Notes of Site Visit

Cullaton Lake Mine

**Prepared for
Nunavut Water Board**

**Prepared by
Acres International Limited
Suite 500, 10201 Southport Rd. SW
Calgary, Alberta
T2W-4X9**

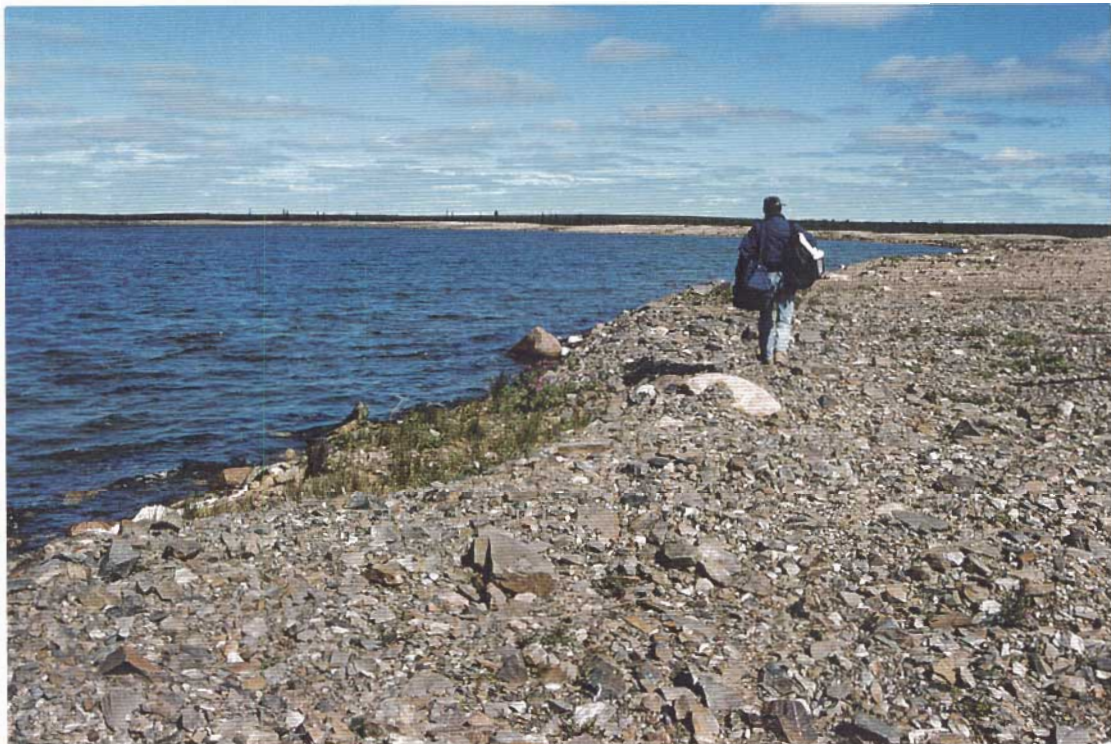
The voids in the landfill material may result in additional areas of settlement and collapse, particularly along the shoreline area. These areas pose a man-made hazard for future use of the site and should be repaired. Additional rockfill should be placed along the shoreline area to provide sufficient cover over the exposed areas and to accommodate future settlements until the till cover has become stabilized.

Collapse of till cover over demolition debris along west shoreline of Quarry.

Protruding pieces of metal demolition debris buried in landfill area in quarry.

Flocculated tailings in suspension due to wind and wave action forming shallows in Tailings Pond #1 near spillway. These materials have potential to spill out during annual freshet.

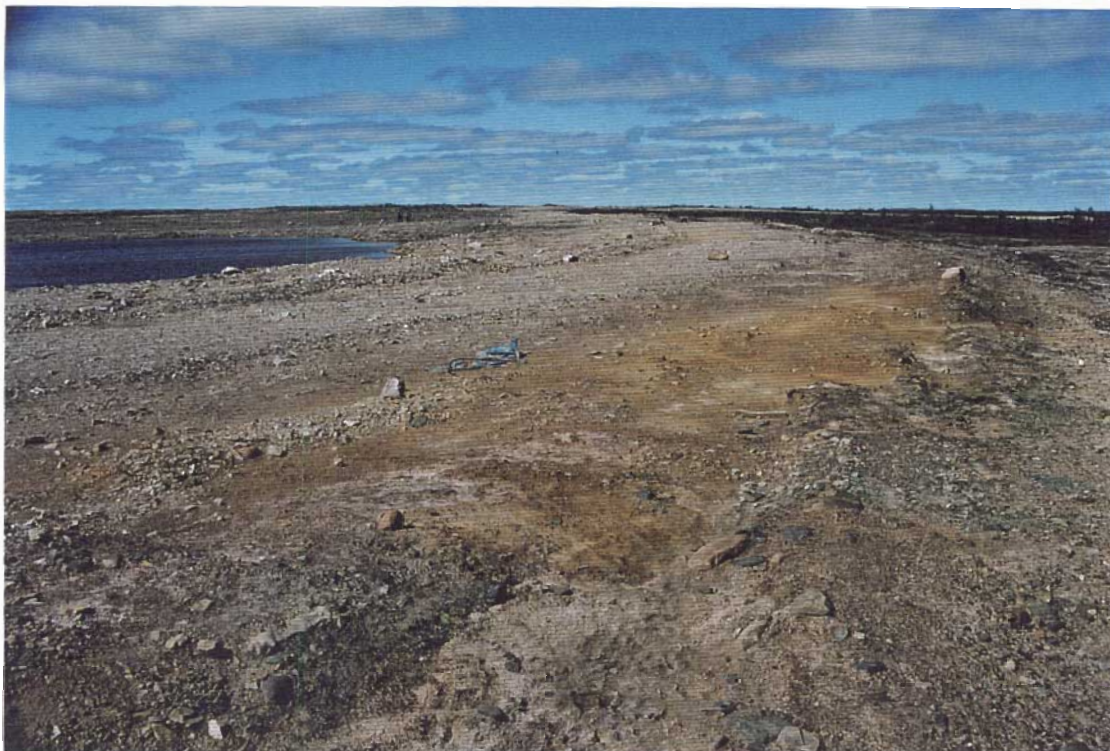
JP pointed out that the tailings were being re-suspended by wave action, resulting in a migrating zone of flocculated tailings, which may be washed out of the tailings pond area during the spring freshet.

Wind induced waves in tailings ponds with shallow water covers (<2 m) can re-suspend tailings and increase oxygen transfer, especially if breaking waves occur. The re-suspended tailings may become oxidized and release metals and acidity more than the tailings at rest.

The suspended tailings driven by wind and wave action may spill outside the tailings containment area during the spring melt. It is important therefore to check the water balance for the tailings pond to make sure that the existing water levels will be maintained for the long term and that excessive spillway discharges do not occur which could erode the dike, or result in more tailings outside the diked area. The chemistry of the suspended tailings should also be checked to evaluate the impact of minor releases. Water quality monitoring should also be done of the spillway discharge during the spring freshet flow period.

Tanks and concrete footings at mill site.

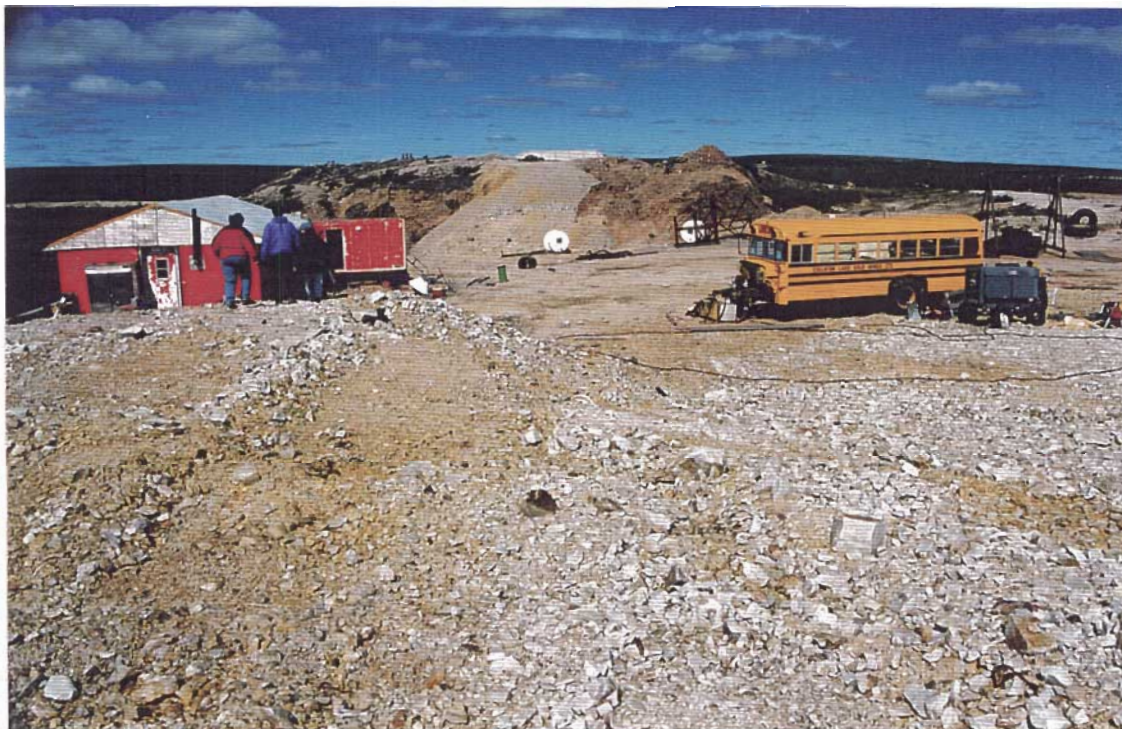
Some fuel storage tanks and concrete building foundations remain at the millsite area. Pallets of drill core are stacked on one of the concrete pads. The surrounding terrain has been mostly leveled and is covered with blasted rockfill and sand and gravel road topping. There were no geotechnical concerns discussed with respect to this area.
